Application for Works Approval

Works Approval Number W6463/2020/1

Applicant Harvey Fresh (1994) Ltd

Premises Harvey Fresh Dairy and Juice Factories
Third Street
HARVEY WA 6229
Legal description – Lot 1 on Diagram 4786, Lot 20 and Lot 22 on Plan 2344, Lot 187 and Lot 189 on Plan 202110, Lot 200 on Diagram 66494, Lot 190 on Plan 202110, Lots 33, 34, 35 and 36 on Plan 205324, Lot 191 and Lot 192 on Deposited Plan 202109 as depicted in Schedule 1 of the Works Approval.

Figure 1: Proposed location of Pond 3, including indicative pump station location, and location of Pond 1, to be desludged.

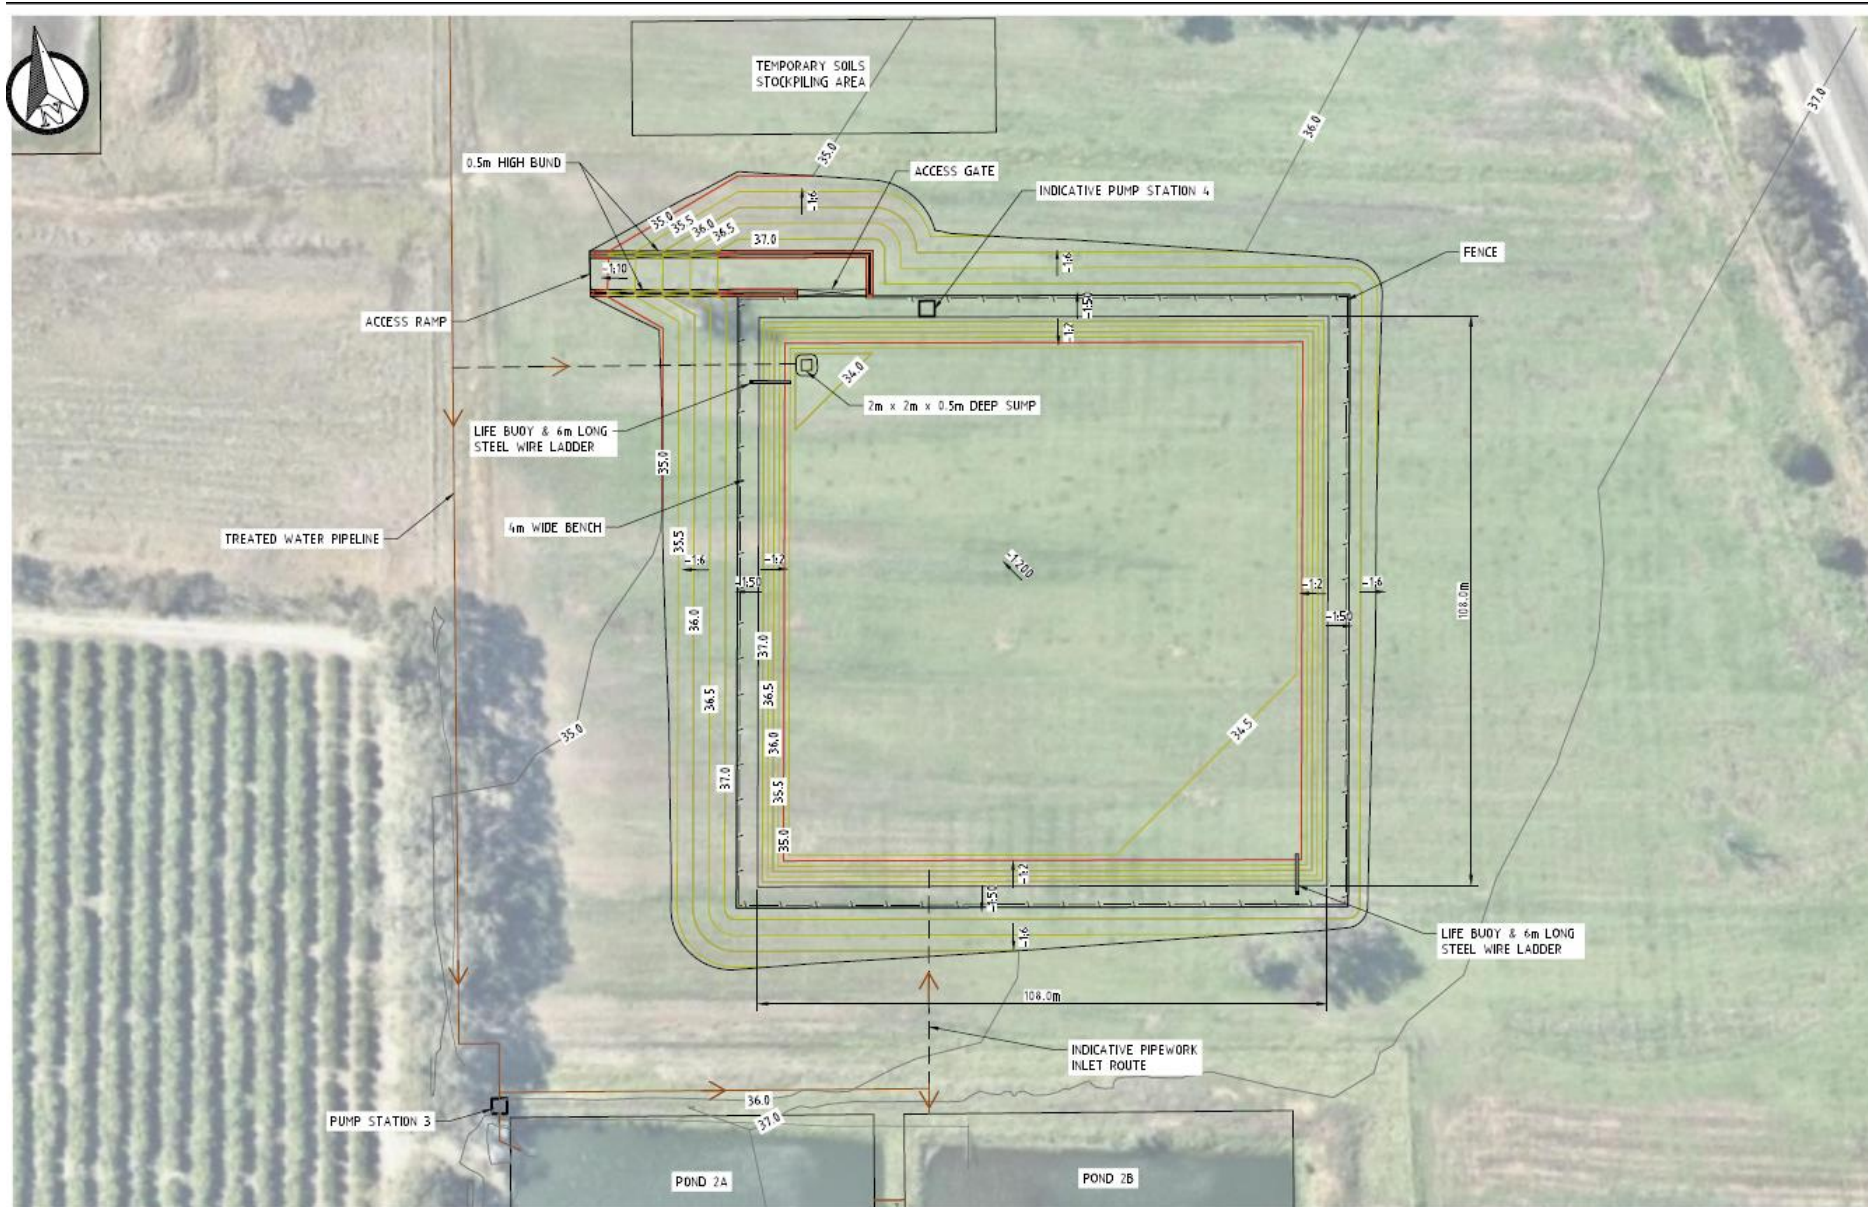
DWER has reviewed the Pond 3 design and has identified the following:

- Seasonal variations in the elevation of the water table beneath the site have been poorly characterised, but it is understood the depth of the water table may seasonably be only 2 mbgl in some parts of the site;

- The lowest excavation point for Pond 3 is approximately 1.7 mbgl, therefore there is a risk that the base of the pond may be impacted by rising groundwater in winter months;

- The proposal to construct Pond 3 partially aboveground increases the vulnerability of the HDPE geomembrane liner to degradation caused by excessive exposure to sunlight. This can cause the progressive loss of plasticisers from the polymers used to make the liner, which in turn can reduce the flexibility of the liner and make it vulnerable to tearing; and

- In situations where a HDPE geomembrane pond liner is constructed in close proximity to the seasonally highest water table elevation, a rising water table can cause the liner to lift, usually in an uneven fashion. The magnitude of this lifting pressure will depend on the head difference between the height of the water that overlies the liner in the lined pond, and the elevation of the water table that surrounds the pond. Under conditions where this head difference is small, the uneven lifting pressure can cause large water and gas “bubbles” to appear in the liner at the base of the pond (Geosynthetic Institute, 2015), but will not necessarily cause long-term

damage to the liner. However, as the head difference between the water level height in the pond and the water table elevation increases, there is a higher risk that welded or glued seams in the liner will tear.

To reduce the risk of exposed areas of the HDPE geomembrane liner being compromised, the aboveground areas of the liner that are likely to be subjected to prolonged exposure to sunlight should be permanently covered with either earth or a sacrificial cover material.

The risk of the liner being compromised by lifting pressure from a rising water table can be mitigated by constructing an underdrain system beneath the entire base of the pond, with a passive gas extraction system to provide a preferential pathway to relieve any gas pressure beneath the HDPE geomembrane. Ongoing monitoring measures are required to demonstrate that the pond does not leak with ongoing use, such as an annual “pond drop” leakage test as outlined in Section 8.6.2 of the New Zealand Institution of Professional Engineers (IPENZ) guidance on the construction and operation of wastewater ponds (IPENZ, 2017). In situations where the “pond drop” test indicates that the liner is leaking, the pond should be drained, and the liner cleaned and inspected before being repaired (Section 8.7 of IPENZ (2017)).
